REMARKS

99 P 3399

FIG 1
(PRIOR ART)

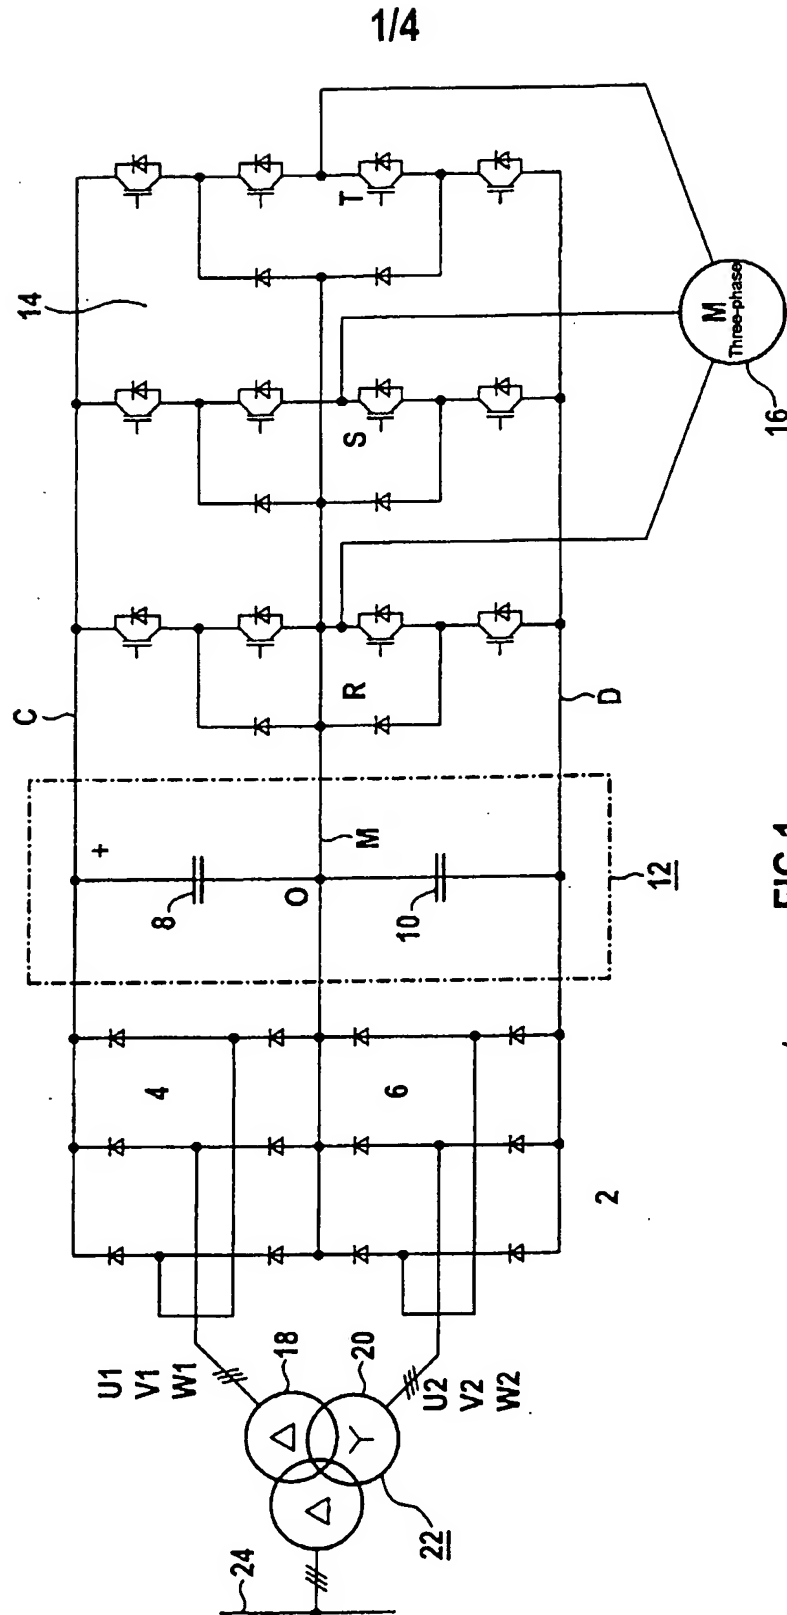
By this amendment, Applicants have amended Figure 1 of the drawings as suggested by the Examiner, and have changed the title of the invention to be more description of the invention.
